**PRELIMINARY GEOTECHNICAL INVESTIGATION
GRANDVIEW RESERVE, FILING 1
EASTONVILLE ROAD AND U.S. HIGHWAY 24
FALCON, COLORADO**

Project No. CS19345-115-R2

January 6, 2022
Revised March 14, 2022
Revised May 9, 2022

SF-23-11

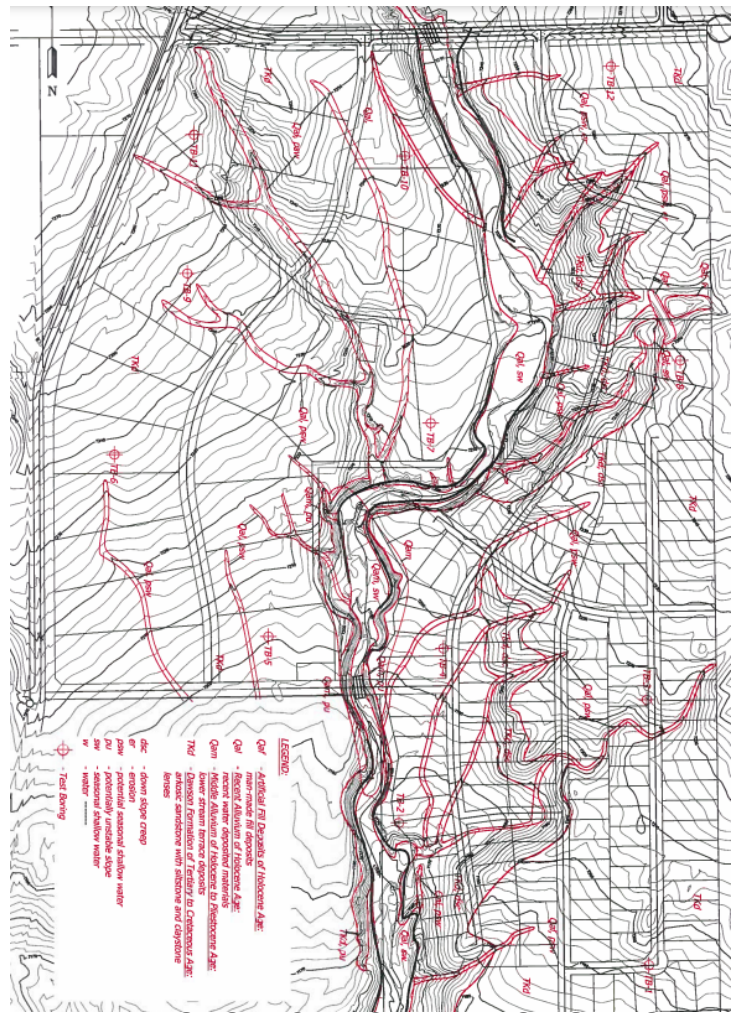
↑ a figure is missing depicting the various constraint and hazard mapping over the lot layout which was deferred from the preimplan- see sample

**Groundwater
Conditions** Fig. 3

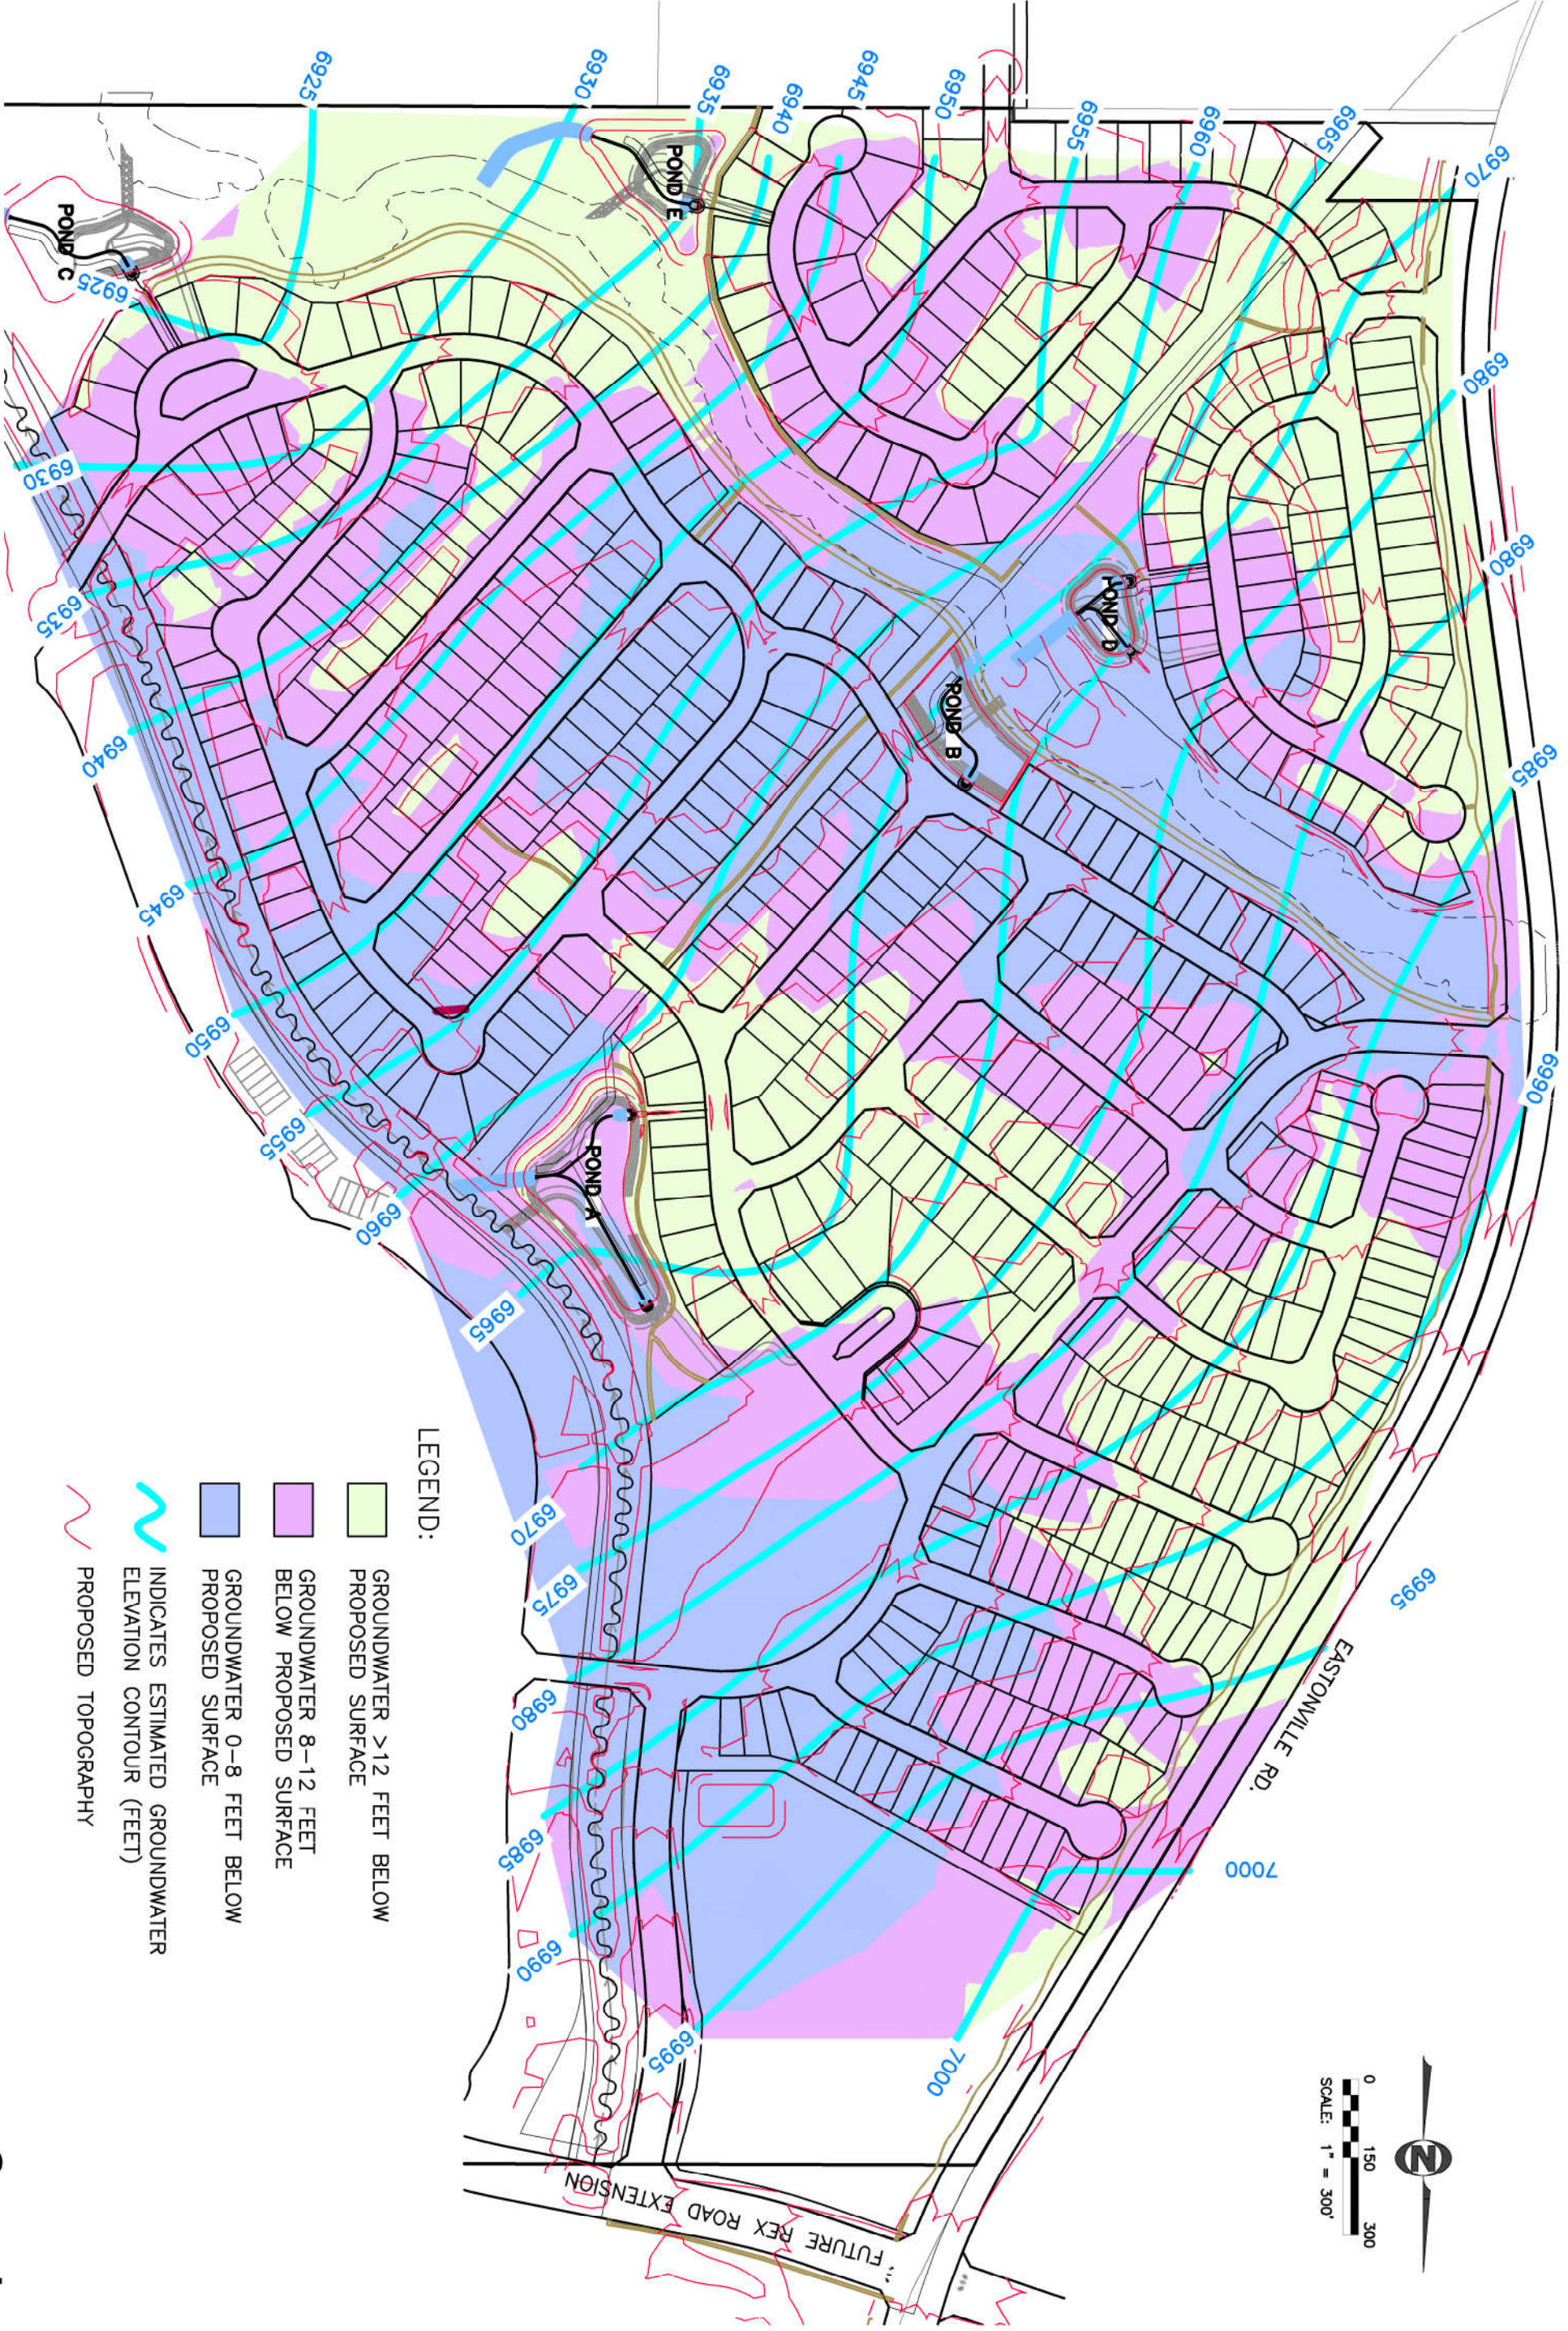
Discuss impact of shallow groundwater on EDB design.
